| BRAKES—PREMATURE REAR BRAKE PAD WEAR—SEVERE DUTY OPERATION—17,500 LB F-550 AND ALL F-450 ONLY | Article No. 00-7-4 |

**FORD:** 1999-2000 F-450, F-550

Figure 1 - Article 00-7-4

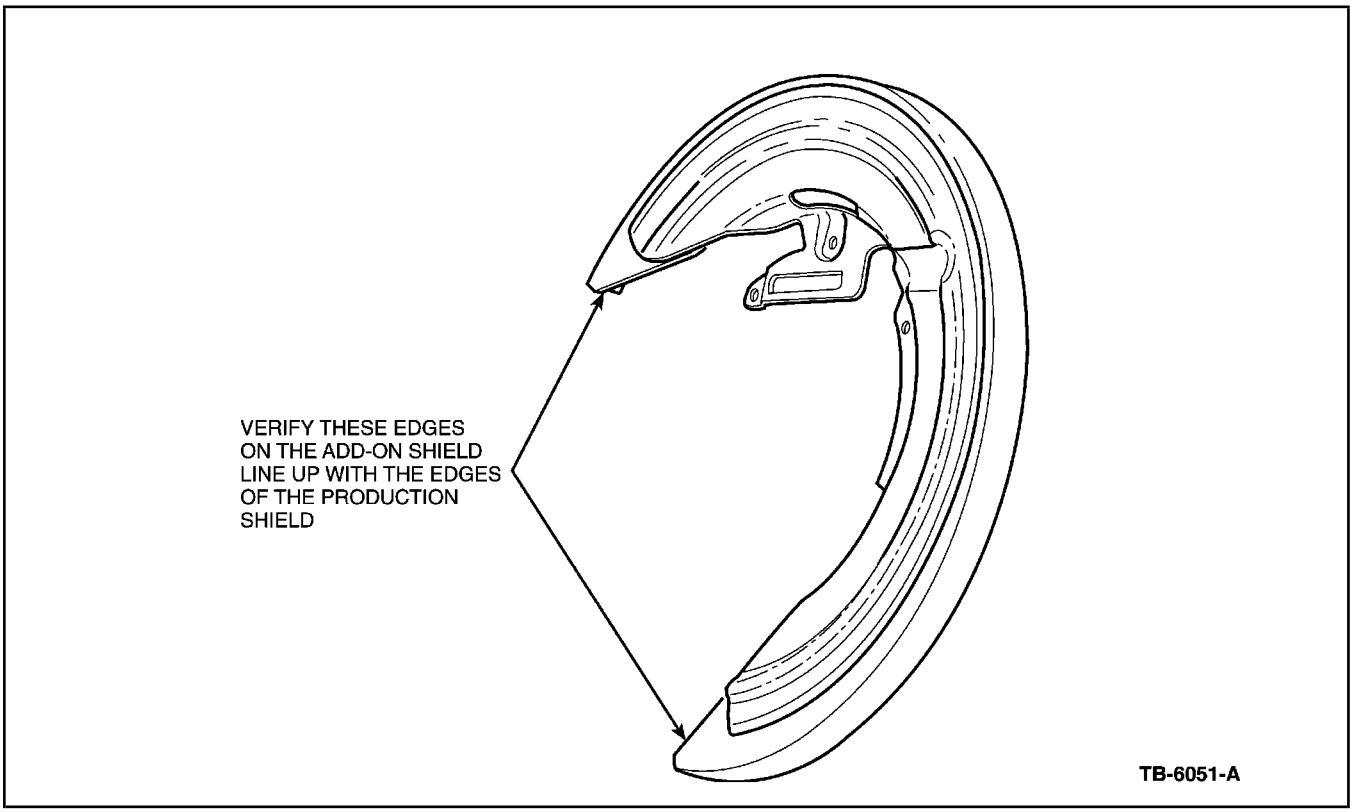
6. Place the Add-on Shield (XC3Z-2B636-BA) on top of the production brake dust shield. Verify the three (3) raised points of the add-on shield fit into the groove of the production dust shield. Align the add-on shield so that the edges align with the caliper opening on the production shield. Clamp in place with visegrips or comparable device (Figure 1).

4. Place the Add-on Shield (XC3Z-2B636-BA) on top of the production brake dust shield. Verify the three (3) raised points of the add-on shield fit into the groove of the production dust shield. Align the add-on shield so that the edges align with the caliper opening on the production shield. Clamp in place with visegrips or comparable device (Figure 1).

Figure 2 - Article 00-7-4

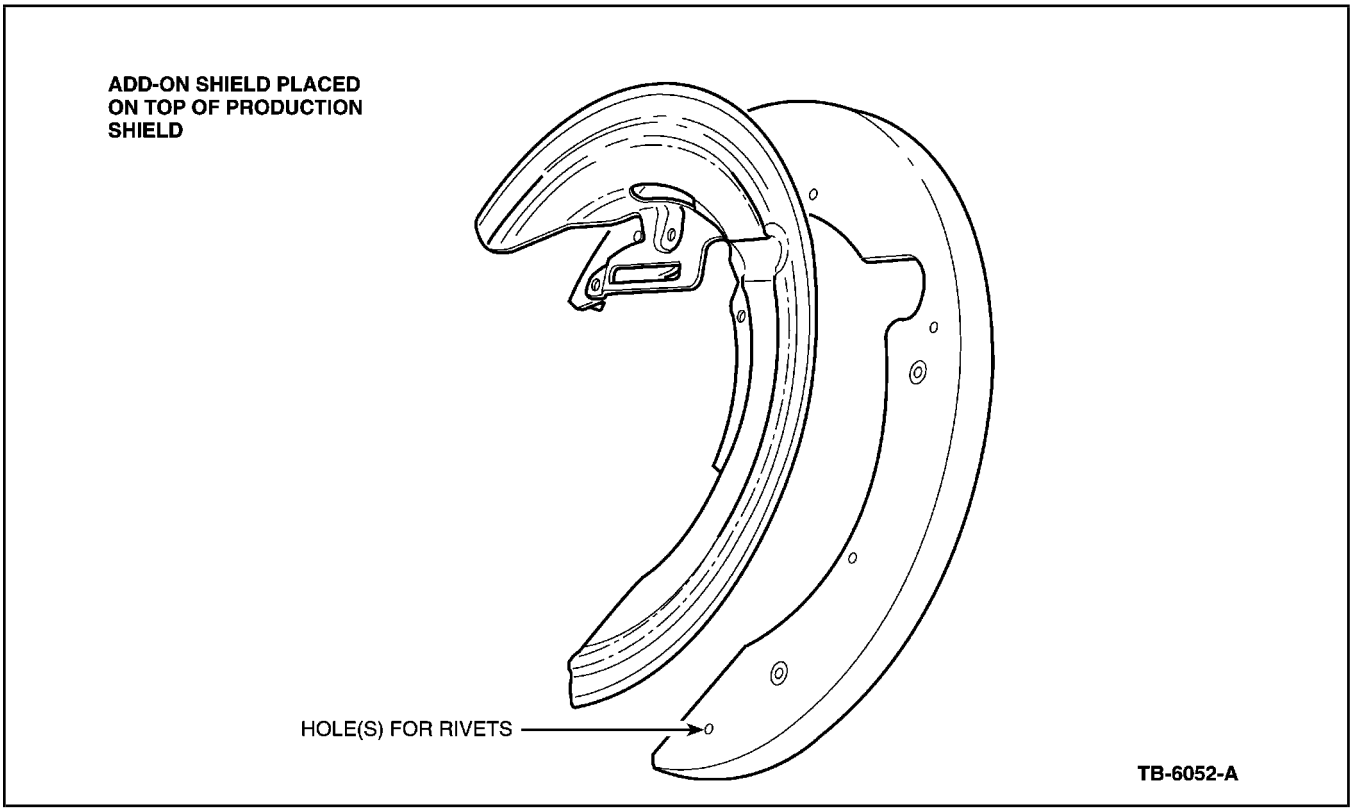
7. Mark the five (5) rivet locations in the production shield using the add-on shield as a template and drill five (5) 4.65-4.90mm diameter holes through the original shield (Figure 2).

5. Mark the five (5) rivet locations in the production shield using the add-on shield as a template and drill five (5) 4.65-4.90mm diameter holes through the original shield (Figure 2).
